Our Ref: J27035 / J31314

RE: ESKOM EIA CONCERNS FOR THE PROPOSED NUCLEAR POWER STATION AND ASSOCIATED INFRASTRUCTURE (DEA Ref. No: 12/12/20/944)

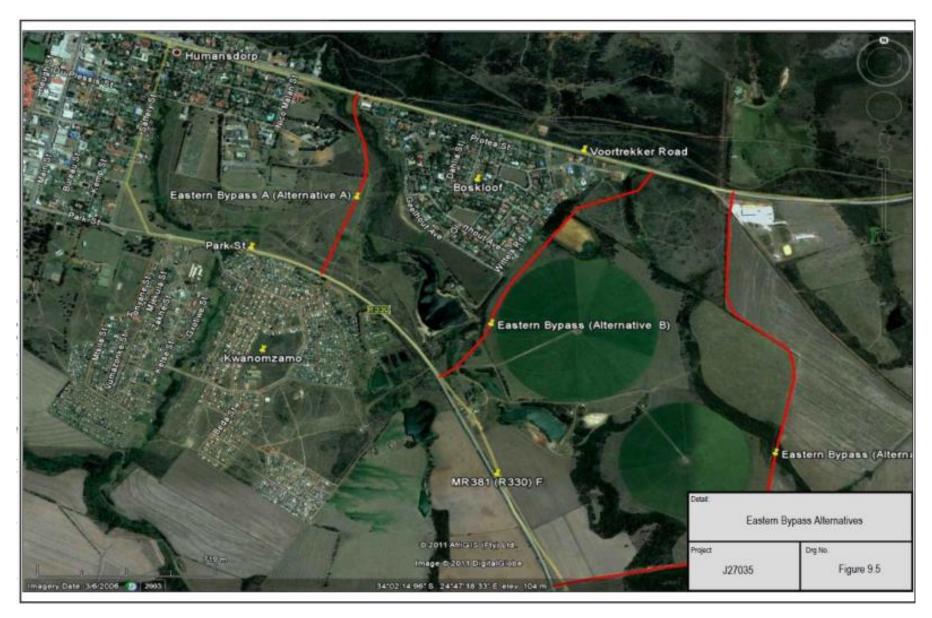
It appears also that the Transport consultant decided that the Eastern Route was preferable and that thereafter Noise Impact and Social Impact consultants assessed the respective impacts and suggested steps to mitigate these impacts. This is also not the best way to find the best solutions. All three consultants should sit down together after visiting the site and jointly find the best solution to the many problems.

The Transport consultant originally identified three possible routes, Northern, Western and Eastern for the transportation of the materials and equipment from the N2 to the Thyspunt site. He apparently did

not consider, nor was he required to, the noise and social impacts of his recommendation and both of these impacts are very significantly different on the respective routes.

The Eastern route (R330) travels through or alongside two populated urban areas for a total distance of four or five kilometers and will have both noise and social impacts in both areas. In the Humansdorp area it travels through the town and between Kwanomzamo and the town and residents of Kwanomzamo who have to get to the town to work or to attend school or to shop or for any other purpose have to cross the road to get there and back.

Lastly as mentioned above the Transportation specialist study has been revised and confirms that the R330 is now proposed to be used for light vehicle traffic and abnormal load transport, and sections will require upgrading for this purpose. The Oyster Bay Road is now proposed to be upgraded to a surfaced road to be used during the construction and operations phases for staff access, light vehicle traffic, heavy vehicle traffic and as an emergency evacuation route for areas such as Oyster Bay. DR1762, which links the R330 and Oyster Bay Road is now proposed to be surfaced to provide improved east-west connectivity. The recommendation that a combination of both Oyster Bay Road

(Route 1 to western access) and R330 (Route 2 to eastern access) be used for transportation during the construction phase, will improve the impact on traffic congestion, noise and safety impacts to a low / medium significance.
